**CONTINUING ELIGIBILITY INSPECTION (CEI) REPORT
FOR FLOOD CONTROL WORKS
Honolulu Engineer District
CEPOH-EC-T**

1. **Project Name:** Waimea River Flood Control Project
2. **Date of Inspection:** October 3, 2007
3. **Inspection Personnel:**

1. Site Plan
2. Info Paper

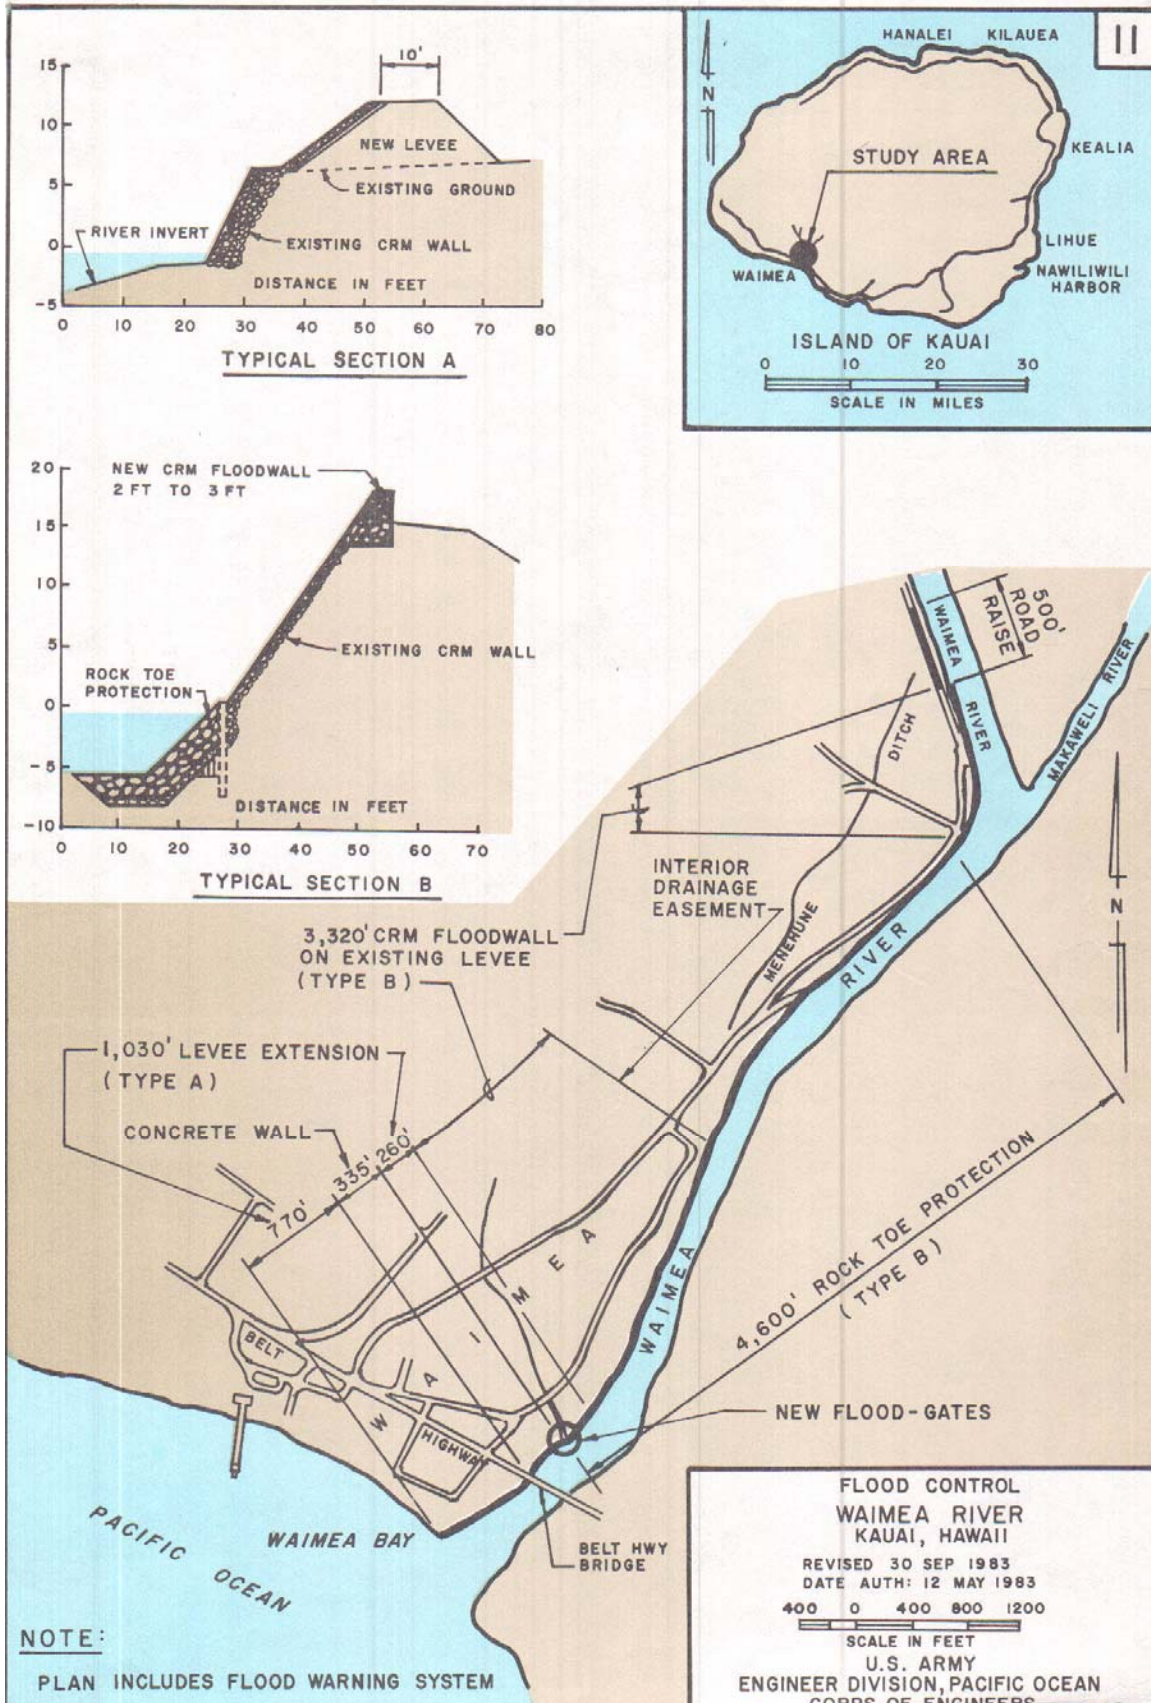
c. RSN 4+20, remove tree stump.

d. RSN 6+50, remove tree stump.

h. RSN 13+50, repair CRM edge at 2 areas.

1. RSN 31+30, Remove juvenile tree stump at waterline of sideslope.

- m. RSN 32+90, monitor townside retaining wall separation approx. one inch.

o. RSN 35+30, Remove juvenile tree stump, patch CRM and grease flapgate.

q. RSN 41+52, Overview of CRM, remove structure in river, @
Culvert # 3.

r. RSN 49+72, Replace broken 24" flapgate.
